Initial Product/Process Change Notification

Document #: IPCN23009X

Title of Change:	Qualification of Shantou Huashan Electronic Devices Co., Ltd., China (SHEDCL) for the Assembly and Test of MOSFET products packaged in TO220F	
Proposed First Ship date:	14 Aug 2020 or earlier if approved by customer	
Contact Information:	Contact your local ON Semiconductor Sales Office or Yuna.Im@onsemi.com	
PCN Samples Contact:	Contact your local ON Semiconductor Sales Office or <PCN.samples@onsemi.com>. Sample requests are to be submitted no later than 30 days from the date of first notification, Initial PCN or Final PCN, for this change. Samples delivery timing will be subject to request date, sample quantity and special customer packing/label requirements.	
Type of Notification:	This is an Initial Product/Process Change Notification (IPCN) sent to customers. An IPCN is an advance notification about an upcoming change and contains general information regarding the change details and devices affected. It also contains the preliminary reliability qualification plan. The completed qualification and characterization data will be included in the Final Product/Process Change Notification (FPCN). This

TO-220 FULLPACK, 3-LEAD

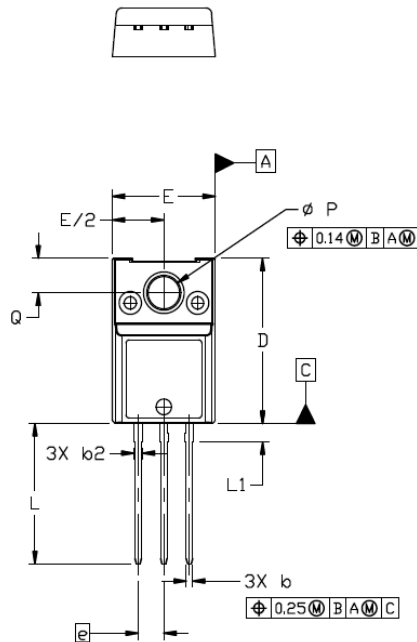
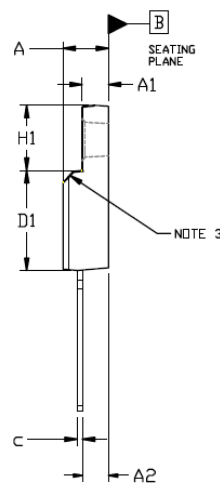
Marking of Parts/ Traceability of Change:	Product from SHEDCL will be marked with site code prior to date code.	
Change Category:	Assembly Change	
Change Sub-Category(s):	Manufacturing Site Transfer	
Sites Affected:		
ON Semiconductor Sites	External Foundry/Subcon Sites	
None	SHANTOU HUASHAN Electronic Devices Co., Ltd., China	
	Tak Cheong Electronics Shanwei, China	
Description and Purpose:		
	Before Change Description	After Change Description
LeadFrame	TO220FP 3L BARE Cu 1X20 STAMPED	TO-220F 3L Bare Cu 1x20 STAMPED
Die Attach	SOLDER PbSn5Ag2.5	SOLDER Pb93.5Sn5Ag1.5
Mold Compound	SG8300HK	KTMC-3097GXA(green)
Assembly Site	Tak Cheong Electronics Shanwei	Shantou Huashan Electronic Devices
	From	To
Product marking change	C	SH

TO-220 FULLPACK, 3-LEAD
CASE 221BN
ISSUE O

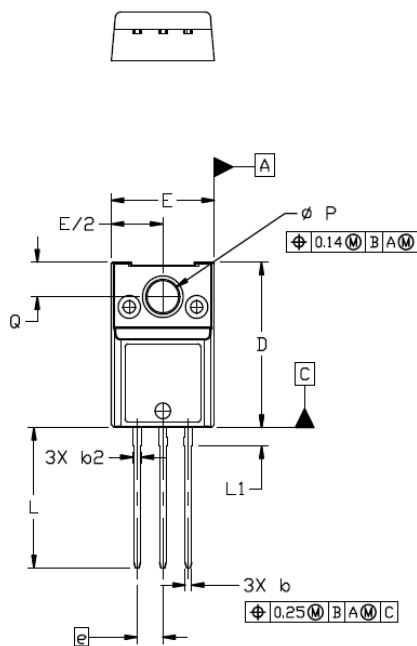
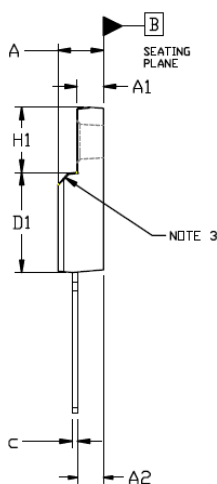
変更件名:	TO220F パッケージの MOSFET 製品の組立および検査工場として Shantou Huashan Electronic Devices Co., Ltd. (SHEDCL、中国) の認定	
初回出荷予定日:	14 August 2020 (またはお客様からの承認が得られた場合はそれ以前)	
連絡先情報:	現地のオン・セミコンダクター営業所または <Yuna.lm@onsemi.com> にお問い合わせください。	
サンプル:	現地のオン・セミコンダクター営業所または <PCN.Samples@onsemi.com> にお問い合わせください。 サンプルは、この変更の初回通知、初回 PCN の日付から 30 日以内に要求してください。 サンプル納入時は、依頼日、数量、特別梱包材/ラベル条件によって異なります。	
通知種別:	これは、お客様宛の初回製品 / プロセス変更通知 (IPCN) です。IPCN は、近日中に実施される変更に関する事前通知であり、変更の詳細および影響を受けるデバイスについての一般情報が記載されます。また、暫定的な信頼性認証計画も記載されます。 最終的な認定データおよび特性データは最終製品 / プロセス変更通知 (FPCN) に含まれます。この IPCN は、変更実施から少なくとも 90 日前に発行される最終製品 / プロセス変更通知 (FPCN) に先だって通知されます。ご不明な点がございましたら、<PCN.Support@onsemi.com> にお問い合わせください。	
変更部品の識別:	SHEDCL からの製品には日付コードの前にサイトコードが表示されます。	
変更カテゴリ:	アセンブリの変更	
変更サブカテゴリ:	製造拠点の移管	
影響を受ける拠点:		
オン・セミコンダクター拠点:	外部製造工場 / 下請業者拠点:	
なし	SHANTOU HUASHAN Electronic Devices Co., Ltd., China	
	Tak Cheong Electronics Shanwei, China	
説明および目的:		
	変更前の表記	変更後の表記

リードフレーム	TO220FP 3L BARE Cu 1X20 STAMPED	TO-220F 3L Bare Cu 1x20 STAMPED
ダイ接着剤	SOLDER PbSn5Ag2.5	SOLDER Pb93.5Sn5Ag1.5
モールド・コンパウンド	SG8300HK	KTMC-3097GXA(green)
組み立て拠点	Tak Cheong Electronics Shanwei	Shantou Huashan Electronic Devices
	変更前	変更後
製品マーキング変更	C	SH
